Access Compliance Report Public Rights-of-Way (Curb Ramps)

Intersection ID: N/A Main Street: GENERAL_DR Cross Street: WESTERN_RIDGE_RD Location: SW

ADA ID: A3CF88A995EB Ramp Type: Combination1Diag Initial Pass/Fail: Fail Overall Compliance: No Severity Score: 0

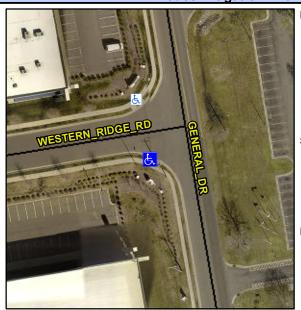
RT RP < 5%

Not Found, R304.5.3, R304.3.2

Remove & Replace Curb Ramp With Two New Directional Ramps or Equivalent.
